Hillsborough County Florida

SM STAFF REPORT

SUBJECT:	PRS 21-0048	PLANNING AREA:	Town and Country
REQUEST:	Minor Modification to PD	SECTOR	Northwest
APPLICANT:	Zion Pentecostal Church of All People, Inc.		
Existing Zoning: PRS 18-0060 (PD 06-0597)		Comp Plan Category: RES-4

Figure 2: Subject Structure Location

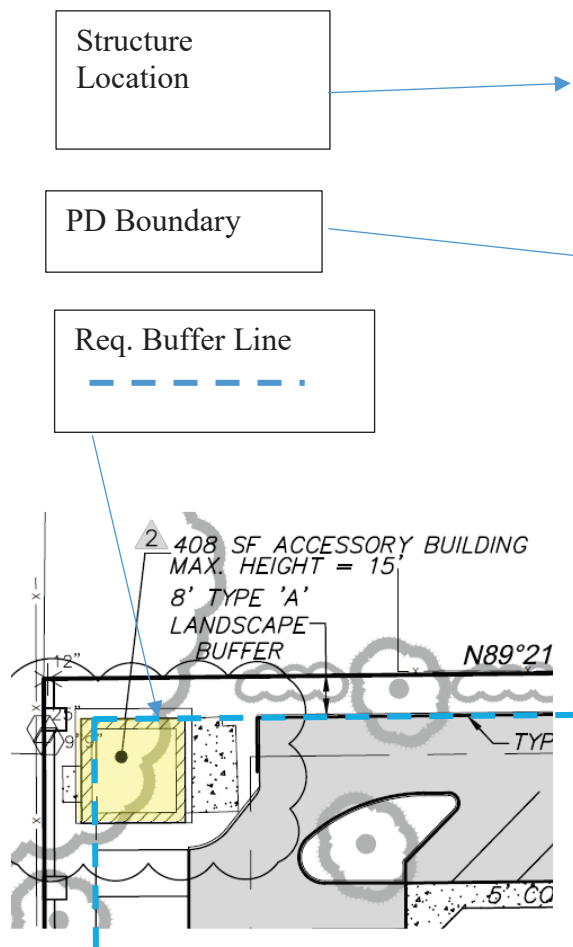
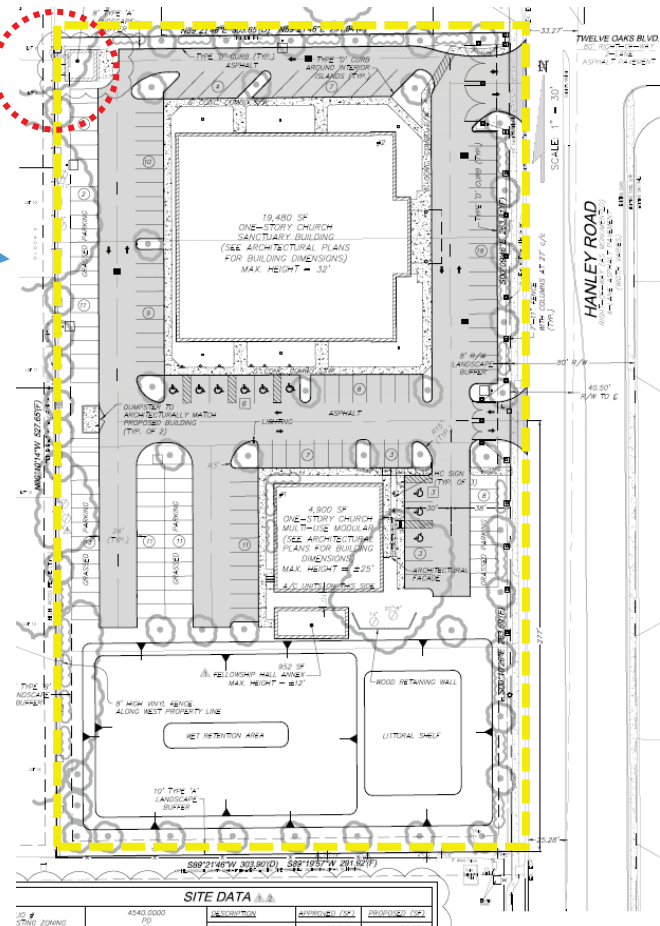
- To increase the allowable building square footage from 25,340 square feet to 25,740 square feet and to allow an existing 408 square-foot accessory structure to be replaced on the northwest corner of the PD. With this increase, the FAR will increase from the approved 0.16 to 0.17, which remains under the 0.25 maximum FAR of the RES-4 Future Land Use category.

Per approved site plan, a 10-foot buffer is required along the western property line. As shown on the site plan submitted by the applicant, the subject accessory structure is set back 9'-9" from the west property line. The applicant requests a 3-inches reduction to the required west buffer to allow a distance of 9'-9" to the west property line.

5. Buffering and screening shall be as shown on the site plan received ~~June 23, 2006~~ October 30, 2020 and consistent with the Land Development Code unless otherwise specified herein. An accessory structure/building shall be permitted to be located 9'9" from the western property boundary in northwest corner of the parcel.

GENERAL SITE PLAN

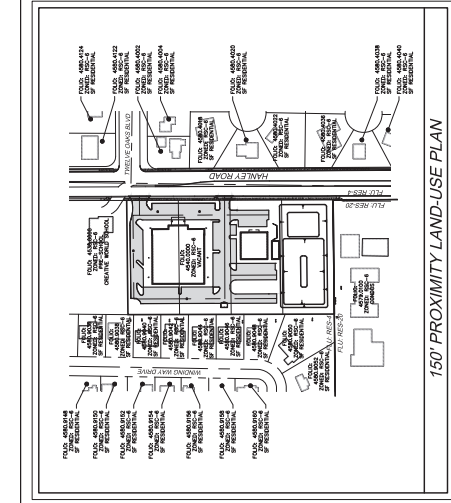
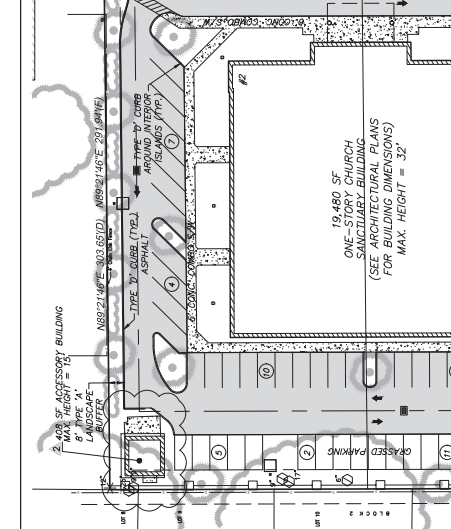
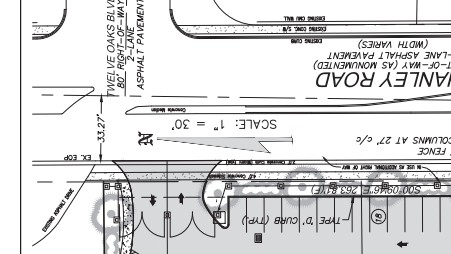
- Condition number 1 is being amended to allow a 408 square-foot accessory building.
- Condition 5 changed to allow the accessory structure to be located 9'9" from the western property boundary in northwest corner of the parcel.
- Transportation Staff recommends deletion condition 8: By its nature, a PD is a site plan-controlled zoning district and the number and location of access points are governed by the PD site plan and conditions of approval.
- Condition 8 is being replaced to include several variance requests regarding number of driveways which may be permitted, requirement for minimum driveway spacing, and requirements to improve substandard roadways.
- Subsections 8.1, 8.2 and 8.3 have been added to describe the nature of the requested variances.

Approval of the request, subject to the conditions listed below, is based on the general site plan submitted ~~October 17, 2017~~ October 30, 2020.

1. The 3.54-acre project may be permitted a maximum of ~~25,340~~ 25,740 square feet of Cultural/Institutional uses (19,480 square-foot church sanctuary building, a 4,900 square foot multipurpose building, ~~and~~ a 952 square-foot fellowship hall annex, ~~and~~ a 408 square-foot accessory building), subject to formal delineation of on-site conservation areas, preservation areas and water bodies and final calculation of maximum intensity (FAR) permitted by the Comprehensive Plan in accordance with the Environmentally Sensitive Lands Credits requirement of the Comprehensive Plan. If the maximum square footage for the project as permitted herein exceeds the maximum intensity (FAR) permitted by the Comprehensive Plan, per the Environmentally Sensitive Lands Credits requirement, the square footage of the project shall decrease as necessary to conform to the Comprehensive Plan.
